LINCOLN COUNTY HEALTH DEPARTMENT
ENVIRONMENTAL HEALTH
WASTEWATER TREATMENT AND DISPOSAL SYSTEM PERMIT

Issue Date: 10/31/2022 (renewal of 10/19/21 pemit) Expiration Date: 10/30/2023

Property Owner: Tim Orchard

RE: Variance Approval

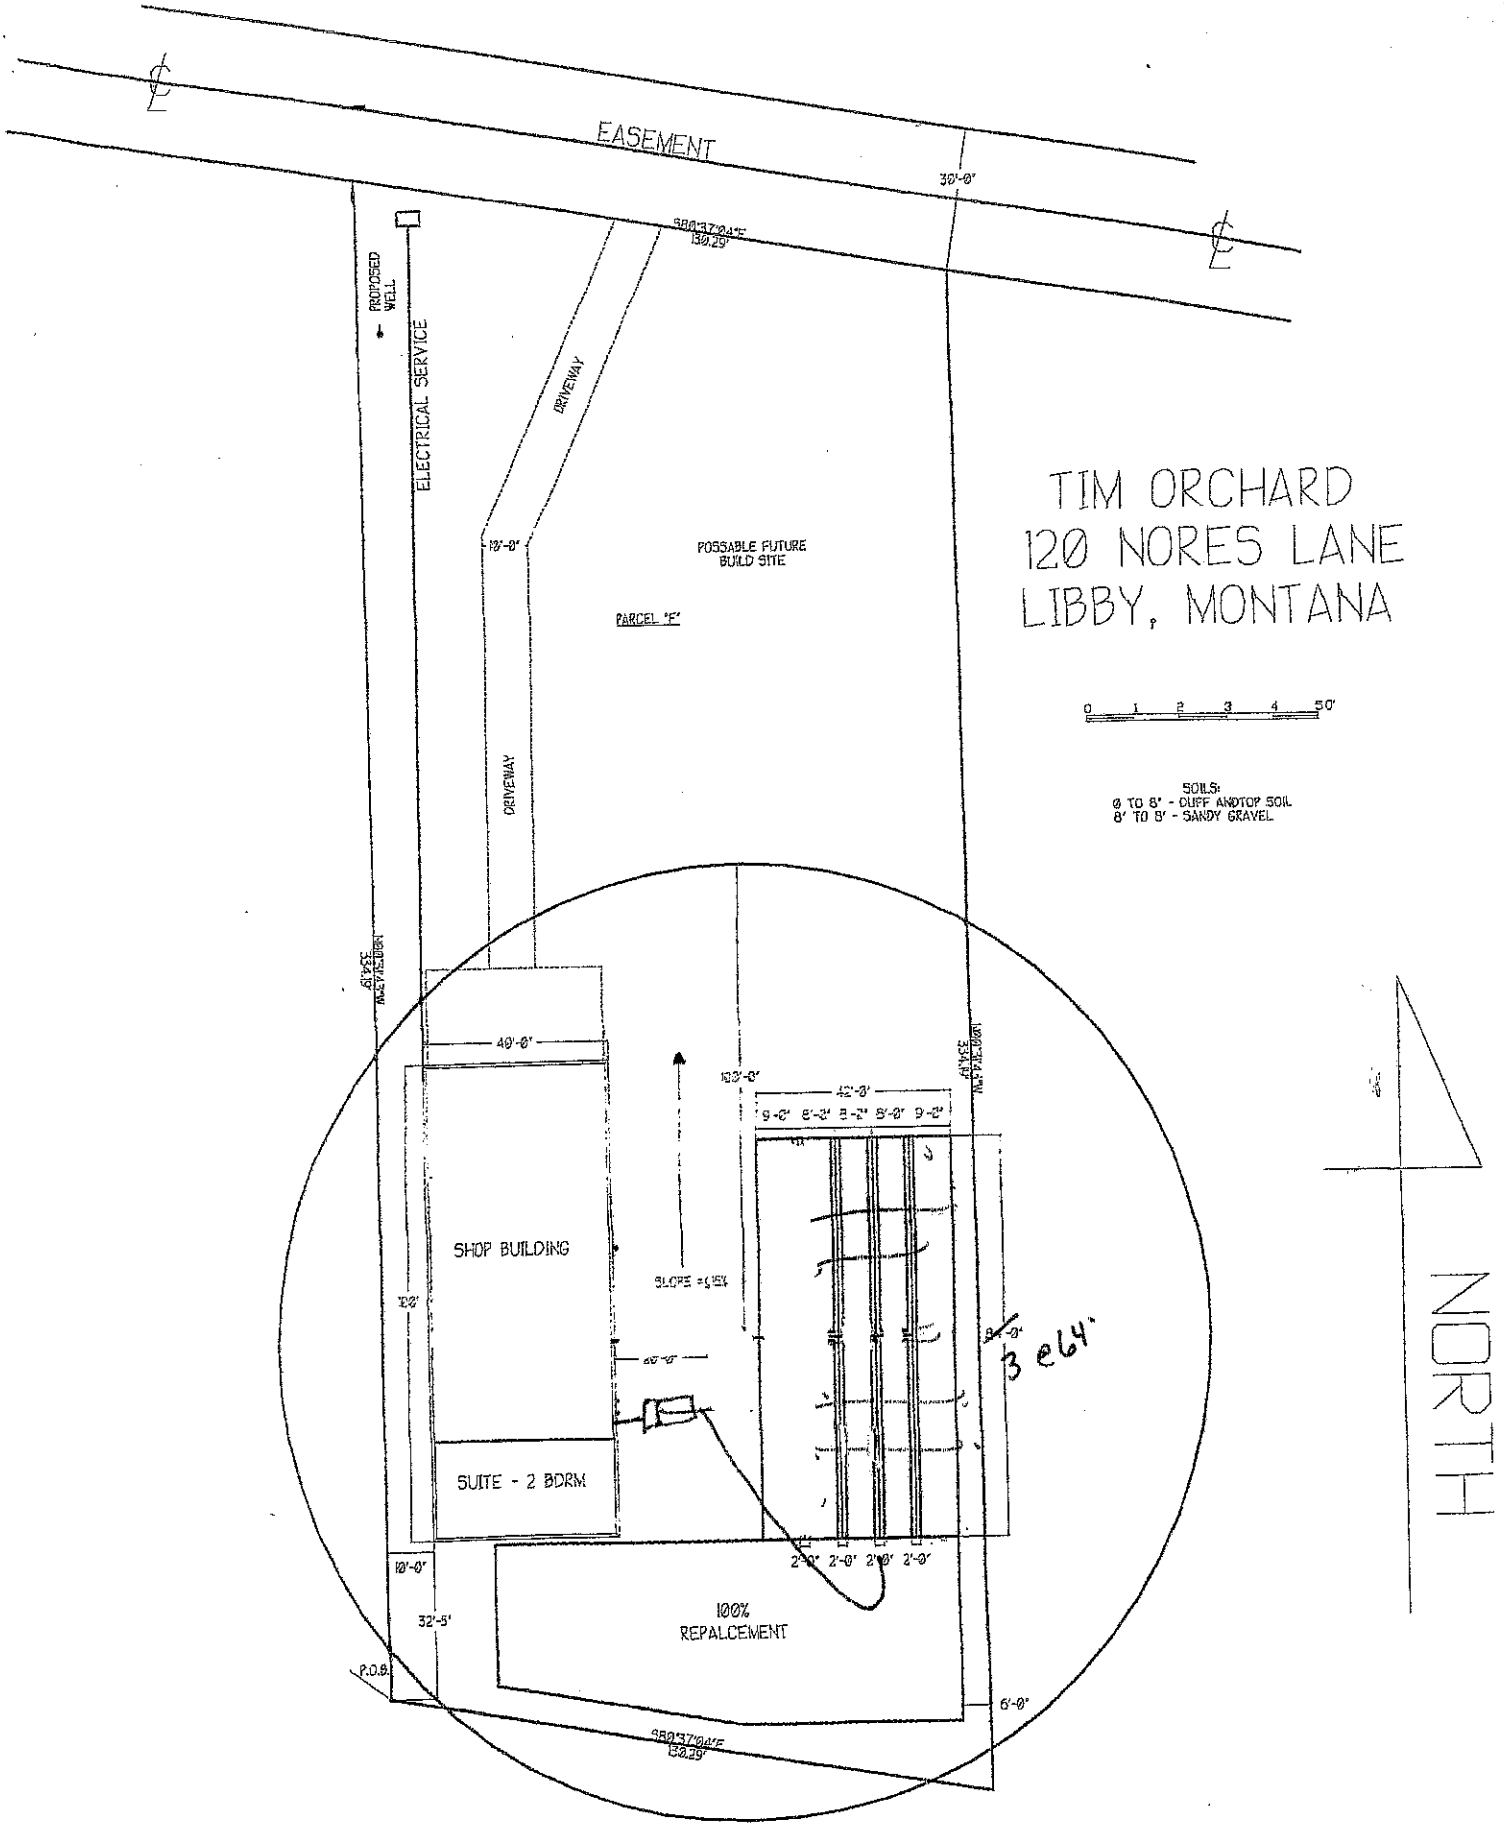
I, Jesse Haaa *, have inspected this system and found it to be in compliance with the approved design criteria, Lincoln County's Wastewater Treatment and Disposal Regulation, and the City-County Board of Health for Lincoln County variance approved 1/10/23.*

The City-County Board of Health for Lincoln County voted at their January 10, 2023 meeting to grant you a variance for your wastewater treatment and disposal system which failed inspection on November 3, 2022. This is a variance to the requirement for a minimum separation of at least 5 feet between trench walls of gravity-fed trenches as required in 6.1.3.3 of Circular DEQ 4.
